Little River Watershed

Total Maximum Daily Load (TMDL) & Water Quality Management Plan (WQMP)

Response to Public Comment

*Prepared by:
Oregon Department of Environmental Quality
December, 2001*

Procedure for the Determination of Essential Shade-Wall

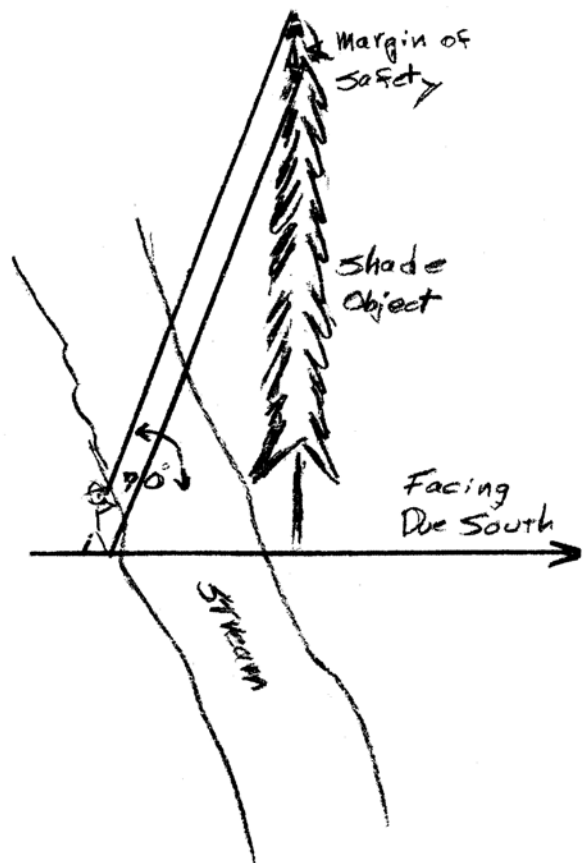
Comment, KS: Page 15 Shade Targets. Since the TMDL is based on stream shade, it is reasonable for a reader to want to know how to identify specifically the vegetation that is essential to fully shade the stream. The following is some suggested text to address this subject:

Since the shade across a stream depends on tree height and the position of the sun, knowing the exact range of the sun’s movement will determine the tree height necessary to fully shade the stream.
